NOTICE TO CONTRACTOR

Limited building only review

Project: Duplex Project  
MODEL: FD-1269  
BUILDER: Elmore Builders

Elevations  
SHEET  
1

Front Elevation  
Scale: 1/4" = 1'0"

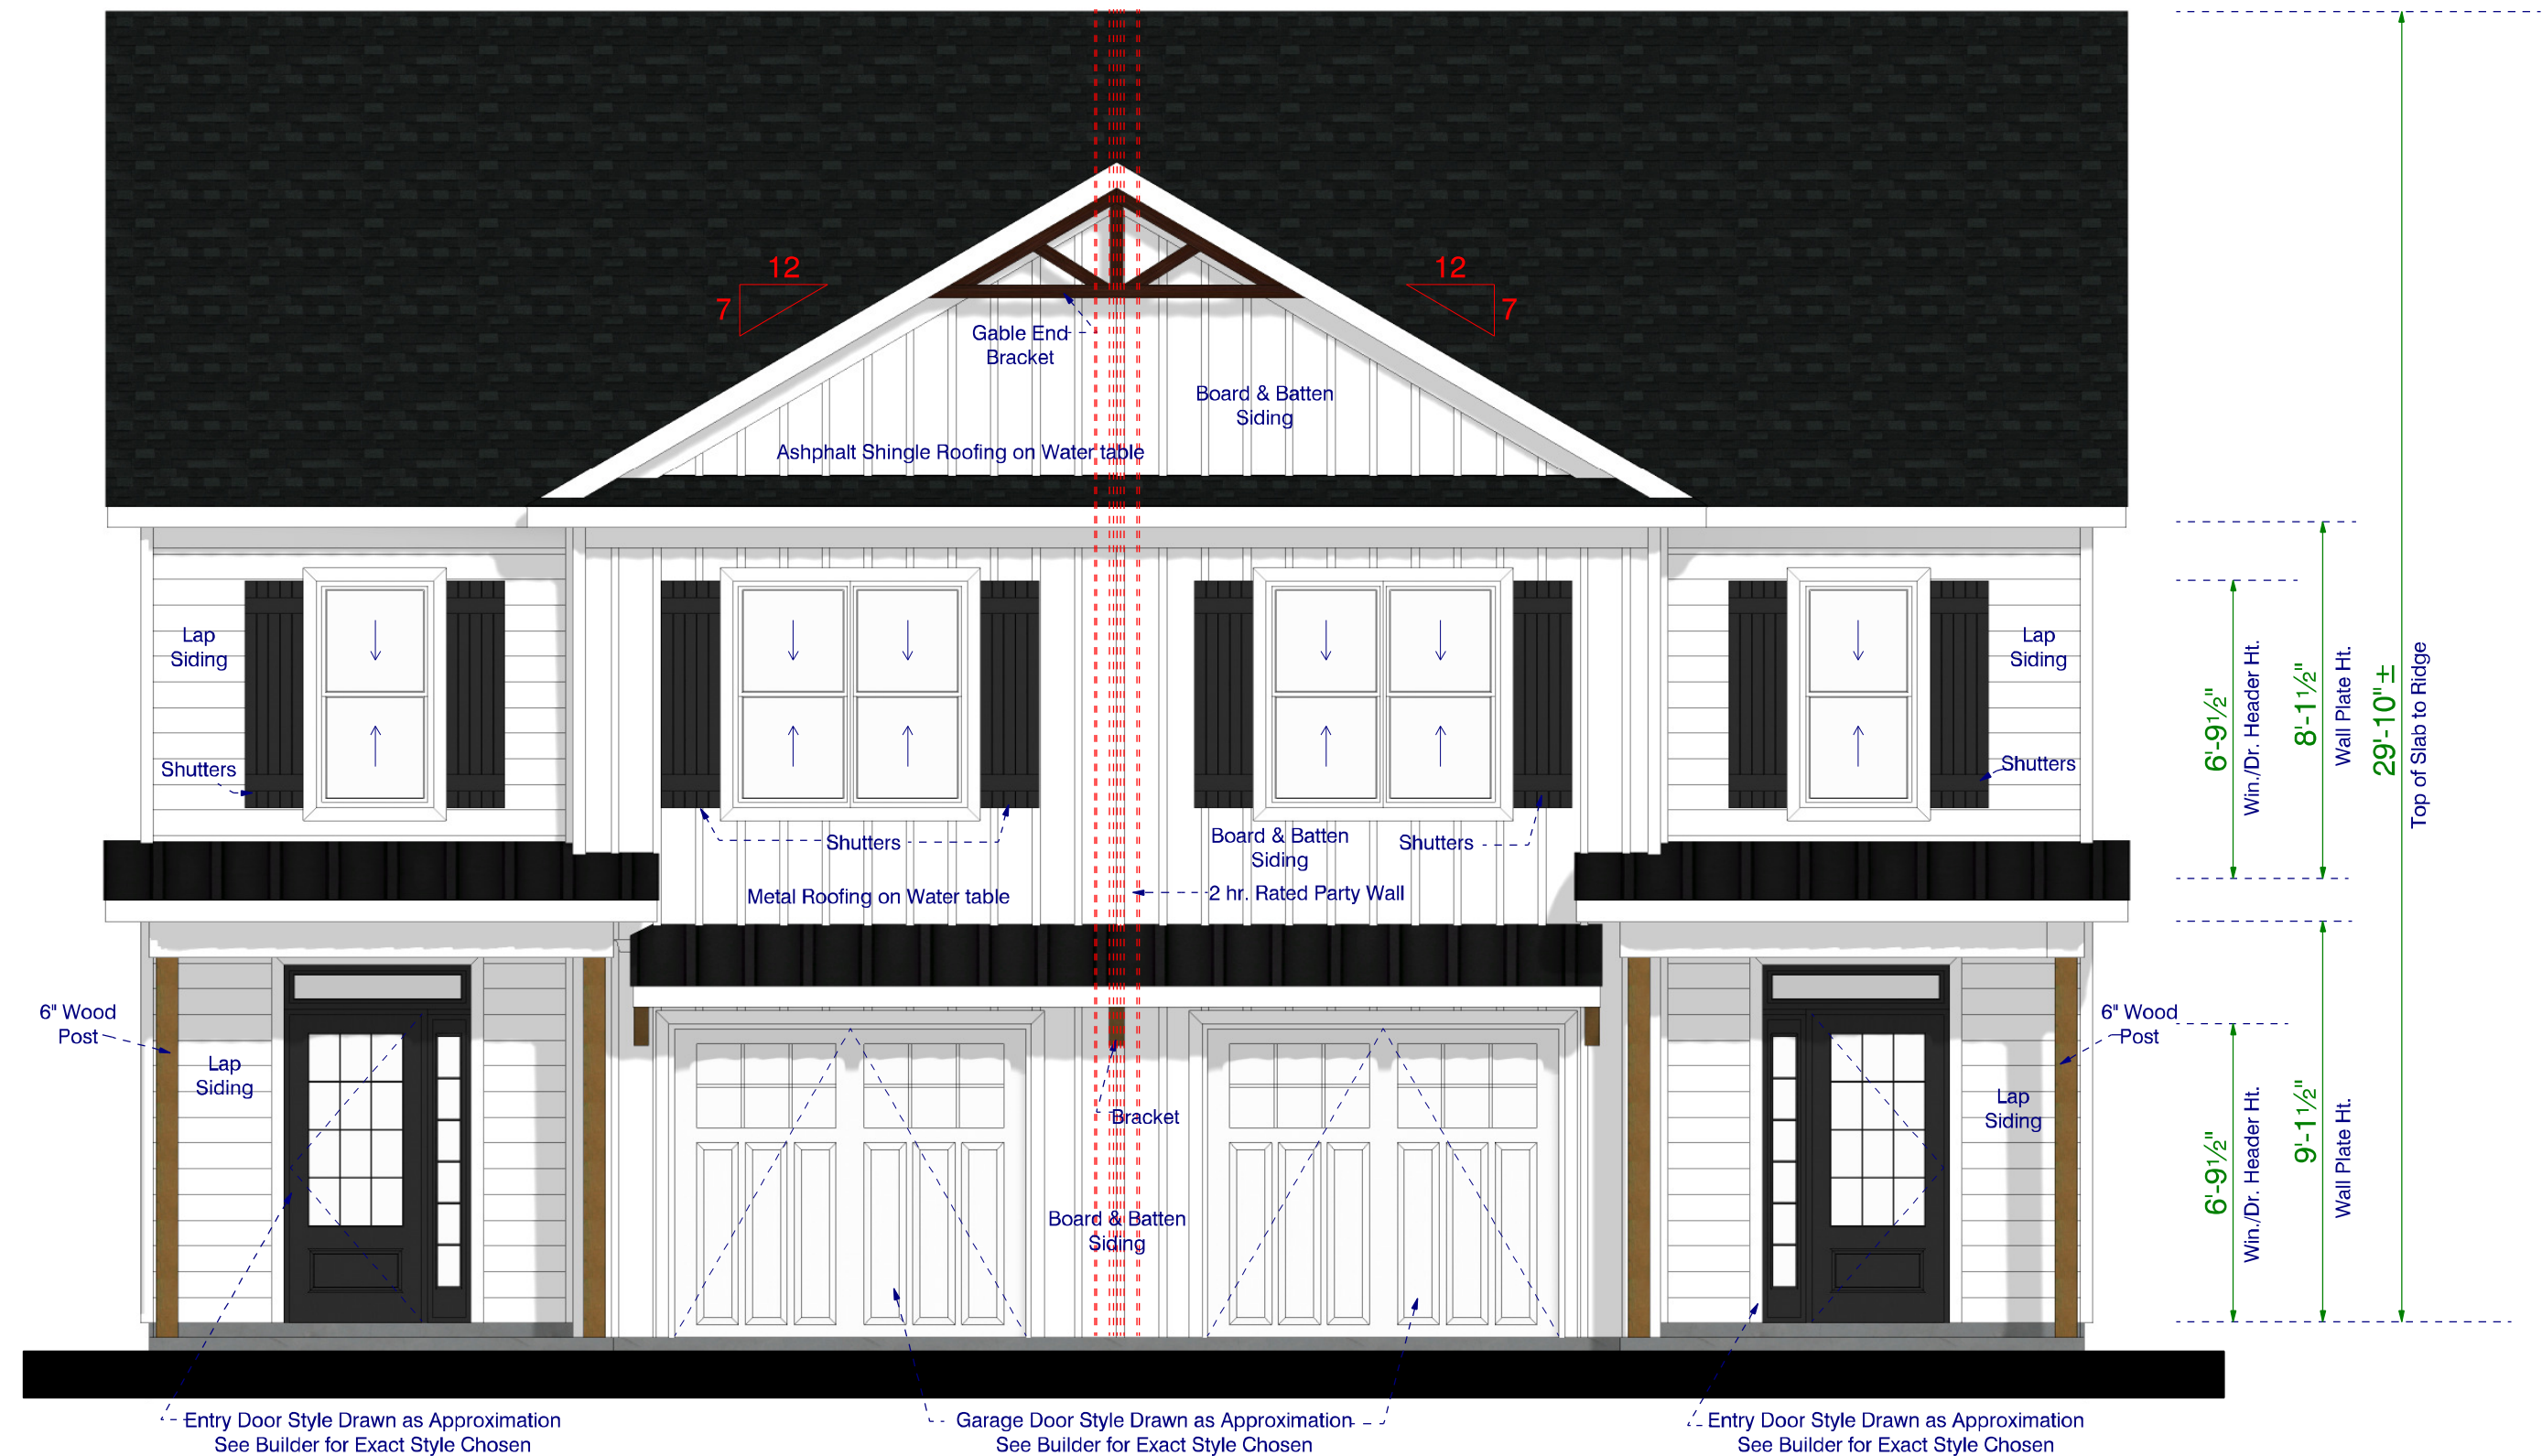
Changed to stemwall. See revisions last two pages
